Re: Initial Review of Notice of Intention to Commence Large Mining Operations, Holliday Construction, Inc., Lime Ridge Mine, M/037/081, San Juan County, Utah

REVIEW OF NOTICE OF INTENTION TO COMMENCE LARGE MINING OPERATIONS

Lime Ridge Mine

105.2 - Surface Facilities Map

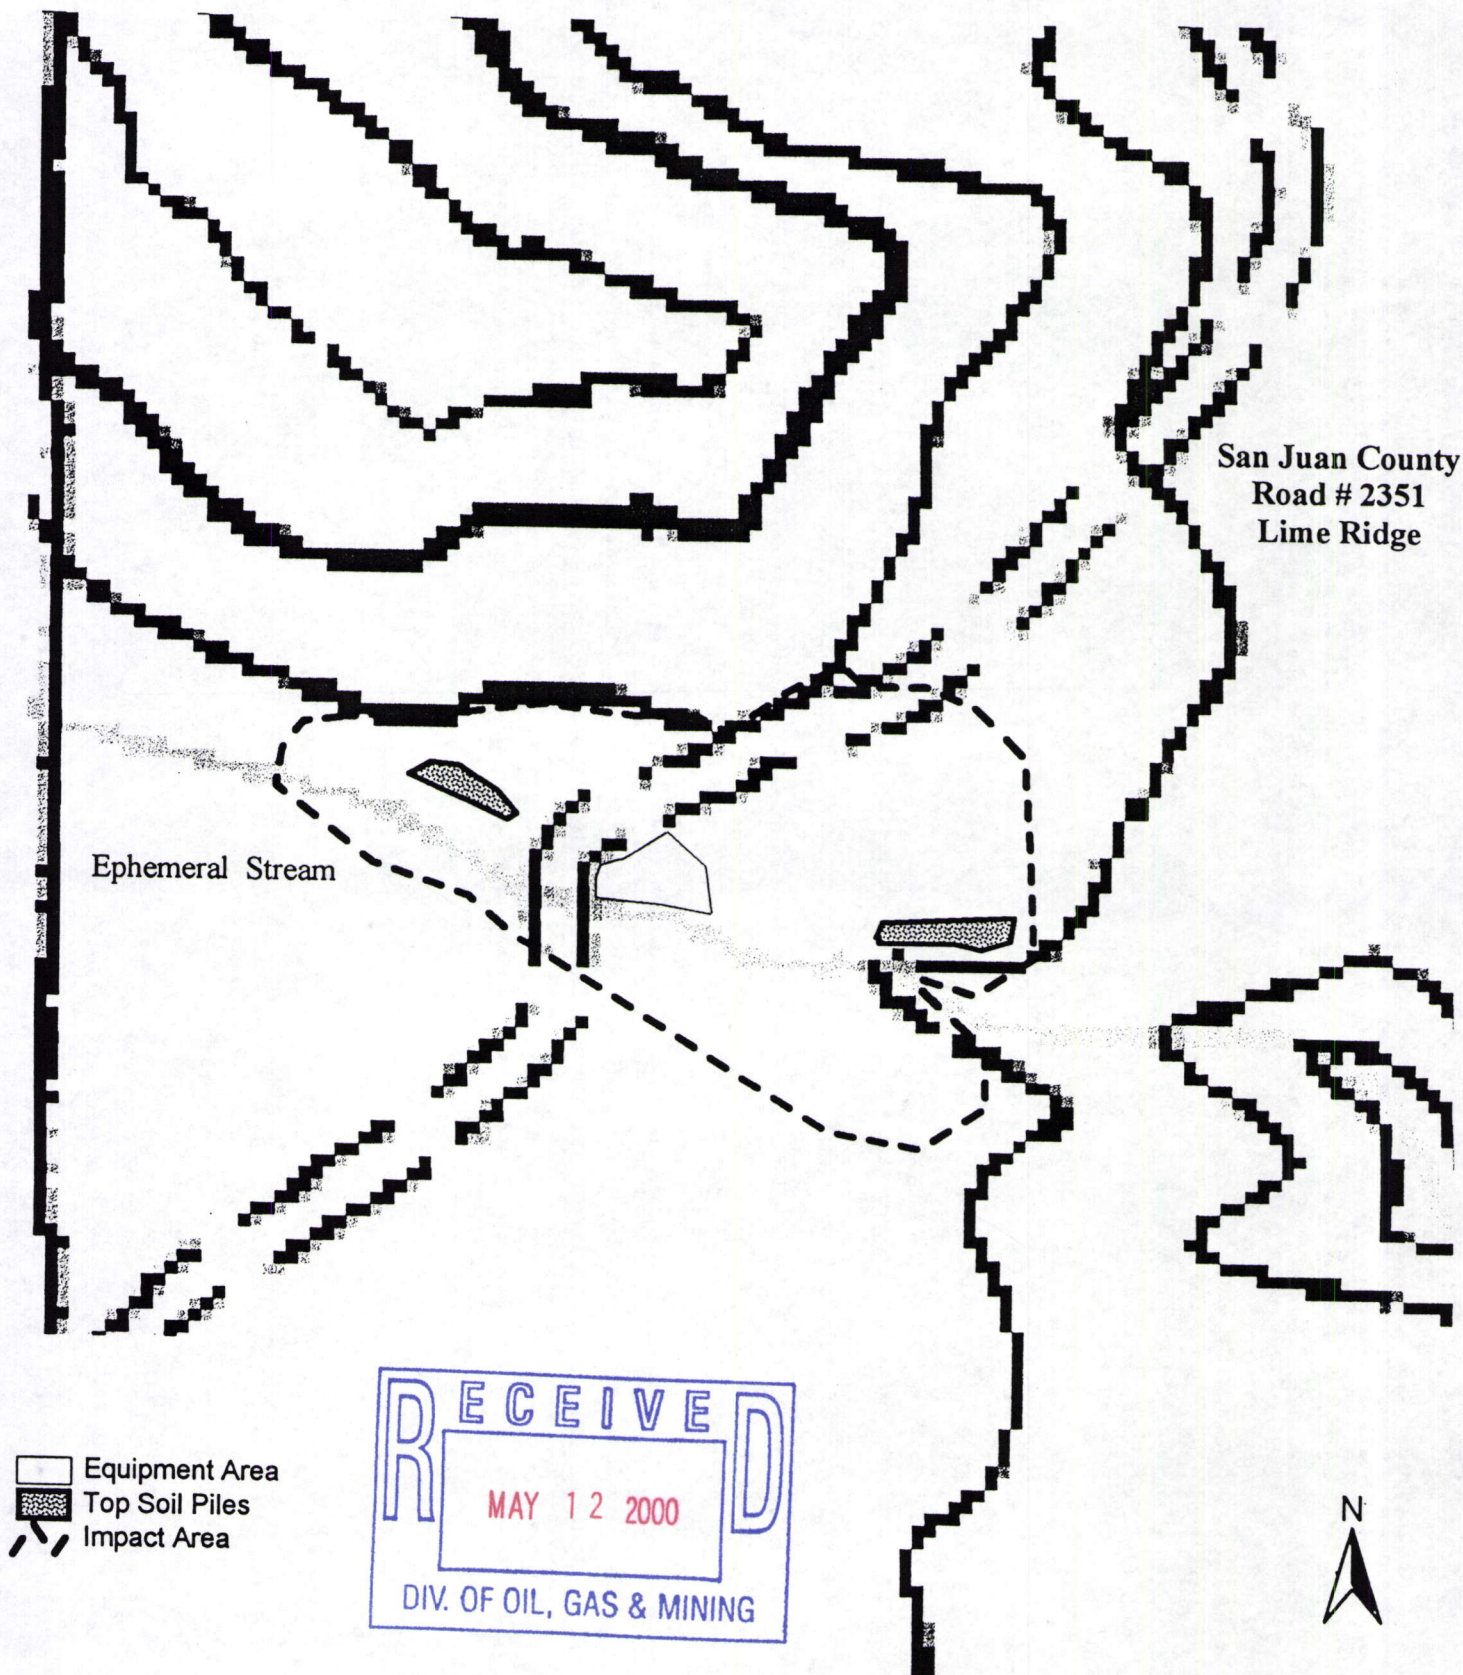
A measurement of the area impacted on the Surface Facilities Map, using the scale shown, gives approximately 2.1 acres. The impacted area described in the text of the submission is 12 new acres plus five (5) acres of existing disturbance. Surety calculations by the Division will not be possible until a scaled map of the proposed disturbance is received. Please provide a revised surface facilities map showing both the current disturbed area and the proposed disturbance. Area measurements from this revised map should agree with the acreage listed in the text of your submission. (AAG)

Please submit a mine plan map showing the mining sequence and projected annual disturbance for a minimum period of five years. (DJ)

It is unclear in the submission whether the nearby ephemeral drainage will be impacted during active operations. Please describe any proposed drainage rerouting during active operations and show this rerouting on the surface facilities map. (TM)

5.3 - Reclamation Map

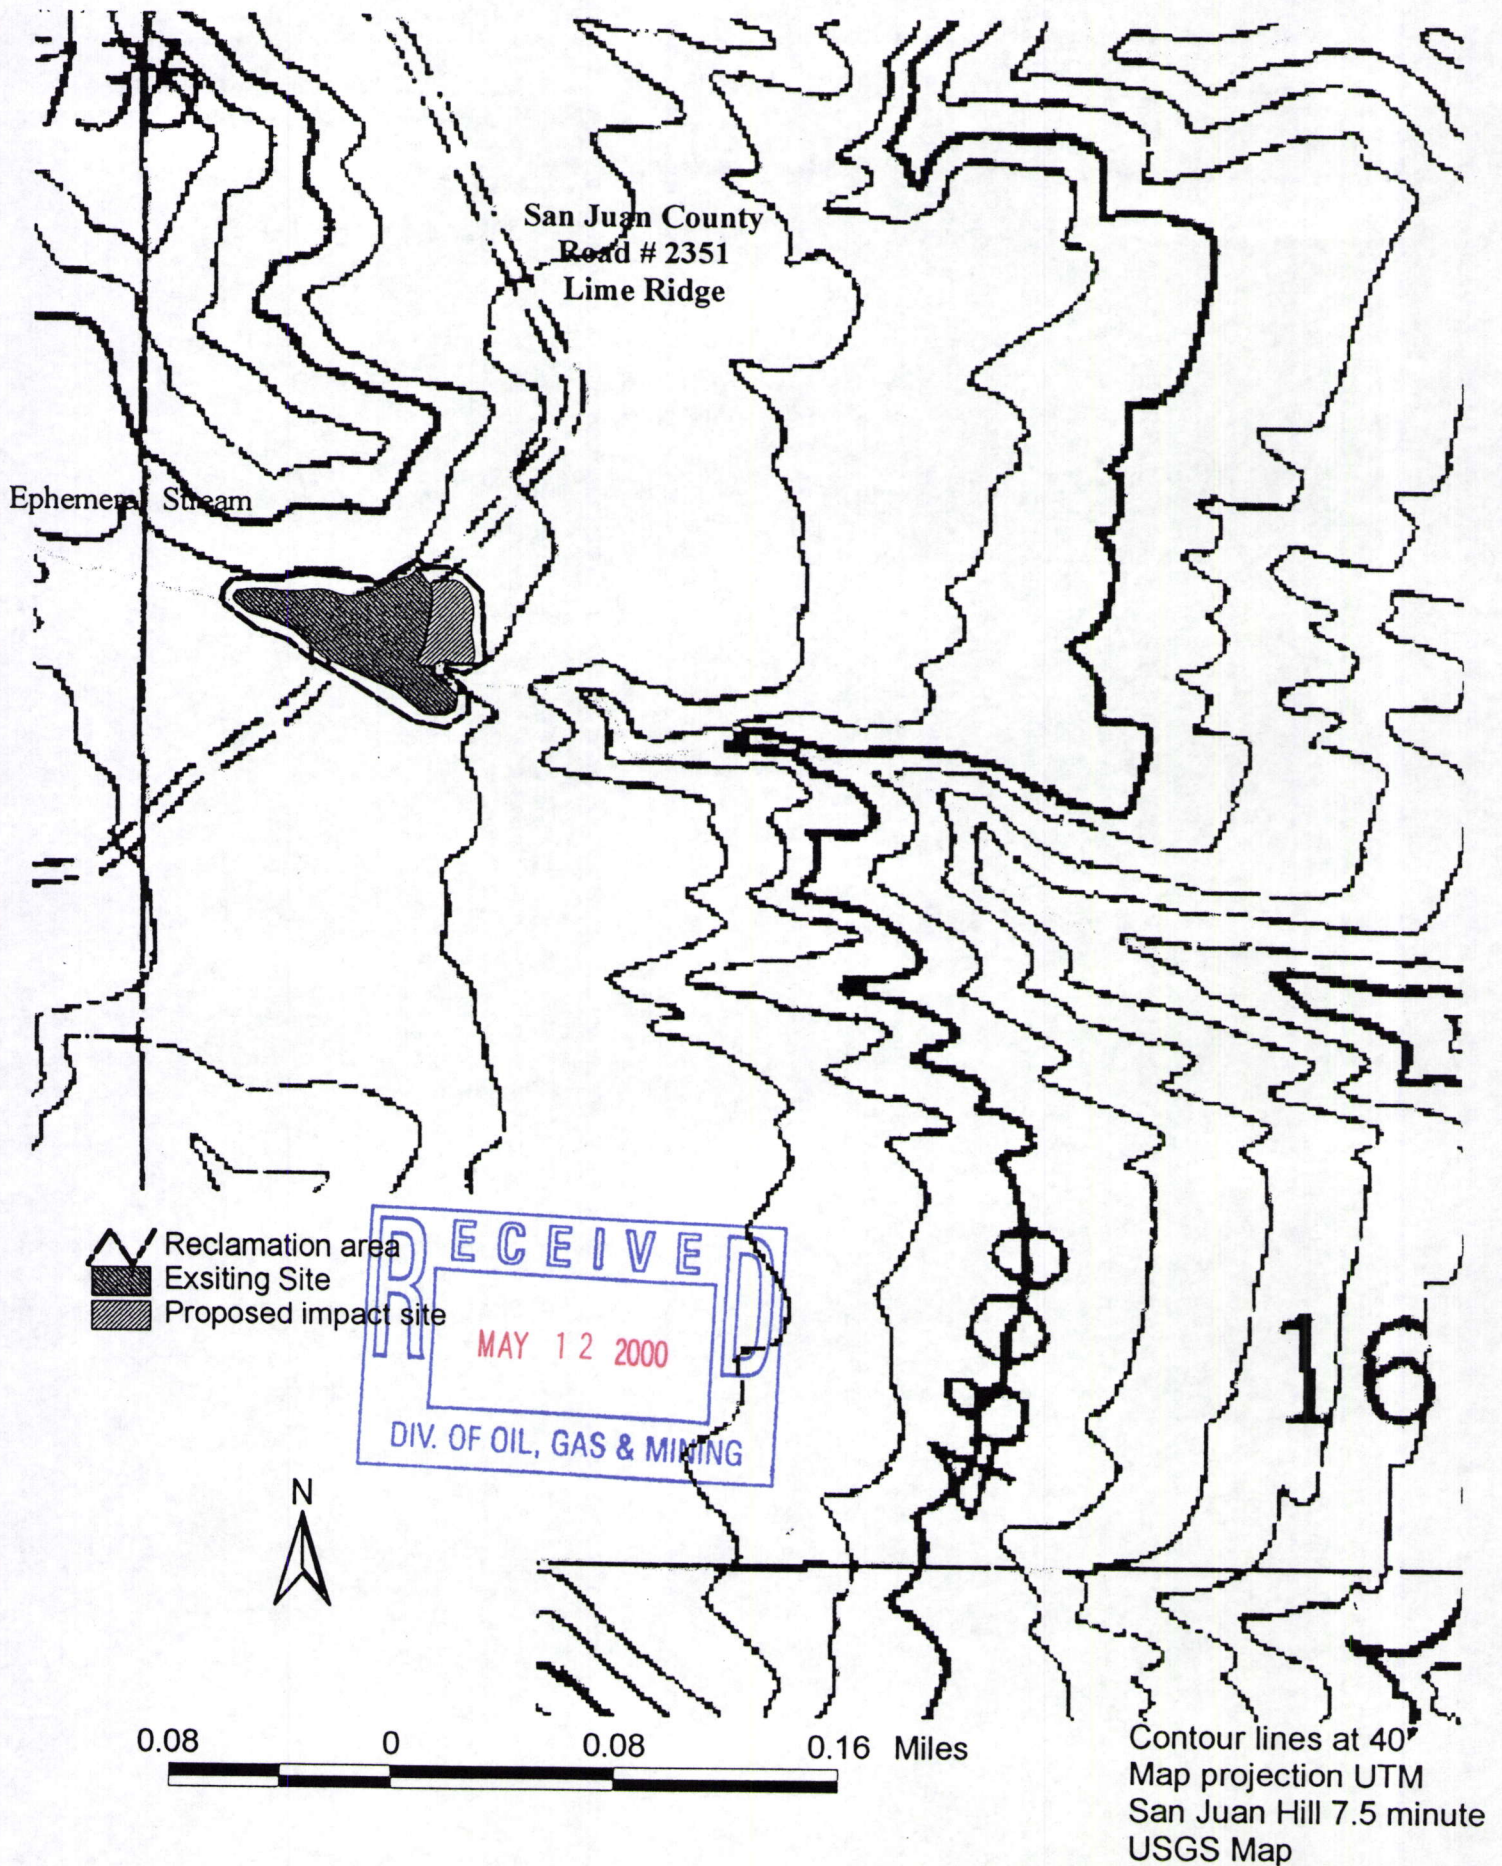
Please provide a reclamation treatments map which is of the same scale as the surface facilities map. Please use cross hatching or color coding on this map to identify areas receiving different reclamation treatments. (AAG)
